Access Compliance Report

Public Rights-of-Way

(Curb Ramps)

Intersection ID: 46533	Main Street: GLEN_HOPE_LN	Cross Street: SUTTONVIEW_DR	Location: S
ADA ID: 198364AED4B6	Ramp Type: PerpDiag	Initial Pass/Fail: Fail	Overall Compliance: No
Severity Score: 42.5			
Codes/Mitigation Info/Possible Solution		Field Measurements/Component Compliance

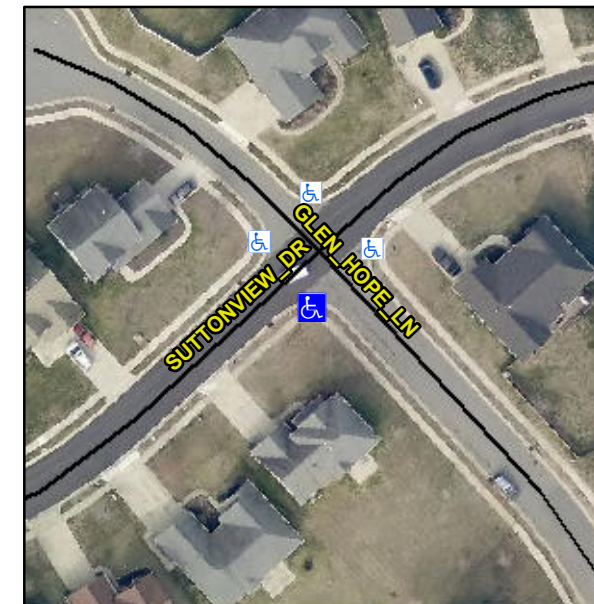
Not Found, R304.5.1, R304.5.3

Compliance	Description	Data	Compliance	Description	Data
N/A	Ramp Length (in)	44.5	Yes	Ramp Slope (%)	5.1
No	Ramp Width (in)	33.0	No	Ramp XSlope (%)	9.9
N/A	Flare Type LT	N/A	N/A	Flare Type RT	N/A
N/A	Flare Slope LT (%)	N/A	N/A	Flare Slope RT (%)	N/A
N/A	Flare Traversable LT?	N/A	N/A	Flare Traversable RT?	N/A
N/A	Landing Length (in)	N/A	N/A	DWS Provided?	N/A
N/A	Landing Width (in)	N/A	N/A	DWS Contrast?	N/A
N/A	Landing Slope (%)	N/A	N/A	DWS Length (in)	N/A
N/A	Landing X Slope (%)	N/A	N/A	DWS Full Width?	N/A
N/A	Landing Curb? (Y/N)	N/A	N/A	DWS Offset (in)	N/A
N/A	Shared Landing?	N/A			
N/A	Gutter Ponding?	N/A	N/A	Gutter Slope (%)	N/A
N/A	Gutter Lip Ht (in)	N/A	N/A	Gutter X Slope (%)	N/A
N/A	Painted X Walk1?	No	N/A	Painted X Walk2?	No
	X Walk 1 Direction	To NE		X Walk 2 Direction	To NW
N/A	X Walk 1 Width (in)	N/A	N/A	X Walk 2 Width (in)	N/A
	X Walk 1 Slope (%)	2.2		X Walk 2 Slope (%)	9.5
	X Walk 1 X Slope (%)	6.5		X Walk 2 X Slope (%)	2.8

N/A	Ramp inside XWalk1?	N/A	N/A	Ramp inside XWalk2?	N/A
	Road Slope (%)	8.1	N/A	Clear Space?	N/A
	Road X Slope (%)	1.0	N/A	Clear Space to XWalk (in)	N/A
N/A	Any Obstructions?	N/A	N/A	Storm Grate/Utility Hazard?	N/A
	Obstruction Type			Storm Grate/Utility Type	
		N/A			N/A
			Yes	Surface Condition? (G/P)	Good

Remove & Replace Curb Ramp With Two New Directional Ramps or Equivalent.
